# Yield Roadway

## Options for Chandler Mill Road

### Executive Summary

## Recommended Traffic Calming along Chandler Mill Road

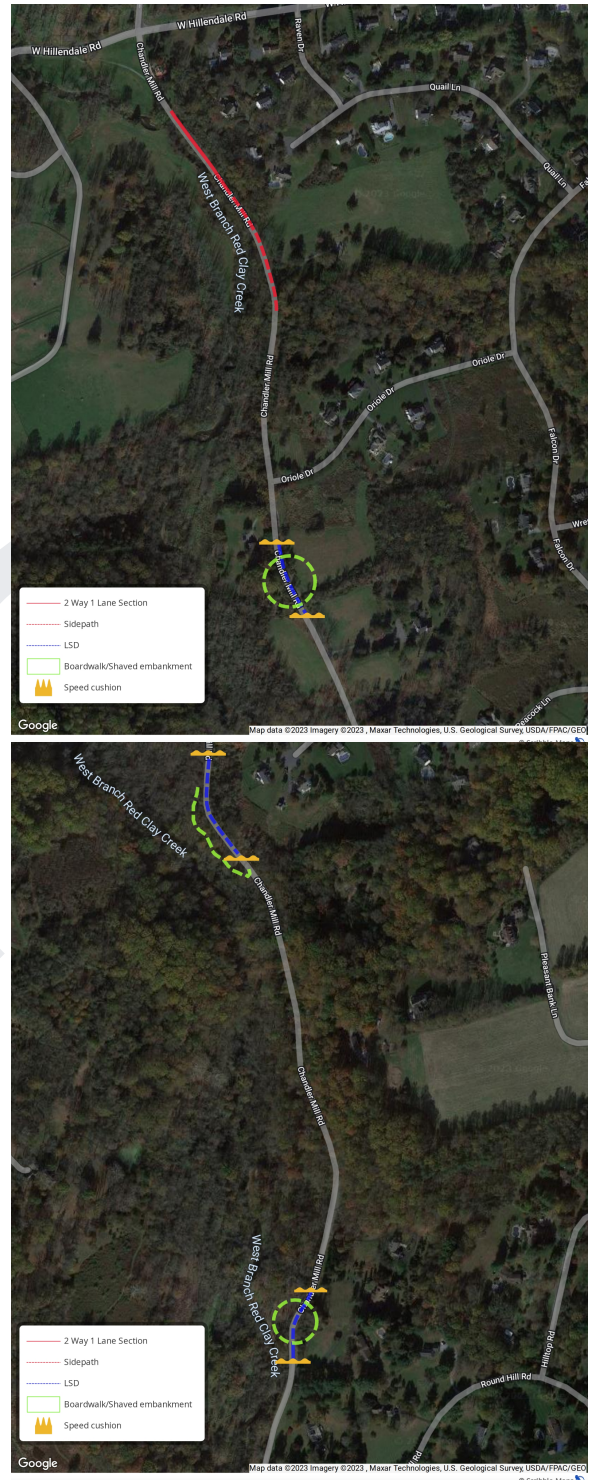
Targeted traffic calming at LSDs involves the strategic placement of pairs of 6' wide [speed cushions](#). Speed cushions are placed one in each lane leaving about 2' gap in between (see diagram below representing the 18' wide roadway). Two pairs of speed cushions are placed on either side of the LSDs. Ideally, one pair of speed cushions is placed where the LSD starts, and the second is placed 150-200' before it to maximize the likelihood of the needed speed reductions. Because speed cushions are generally effective at reducing speeds to 25 or even 20 mph, we can be confident that a speed cushion placed where the LSD begins ensures that we only need an SSD of 125', or possibly as little as 90' if speed drops to 20 mph (see Table 4.7 above). We believe that the lack of a centerline, the approaching curve, and the close placements of the cushions before and after the curve would deter drivers from speeding up through the curve.

We recommend testing this strategy first at the LSD adjacent to the boardwalk with the sharpest curve

(curve 5 in Table 5). This represents the most conservative test of the strategy which, if successful, could provide adequate evidence of the effectiveness of the strategy elsewhere. You can see where cushions would be placed in the pictures below

The pilot would involve speed cushions placed temporarily in the manner described, while prevailing speeds are measured over a one week period. If the pilot is successful and the LSD resolved, then similar measures can be taken at the other two LSDs, and speed studies conducted at each. If the LSD is resolved at all three sites, designers can then move to the next phase; exploring whether other traffic calming measures are needed in between these sections to maintain speed reductions (see below). If the pilot fails to reduce speed adequately to resolve the LSD, additional traffic calming measures could be added (e.g., a third pair of speed cushions at each end).
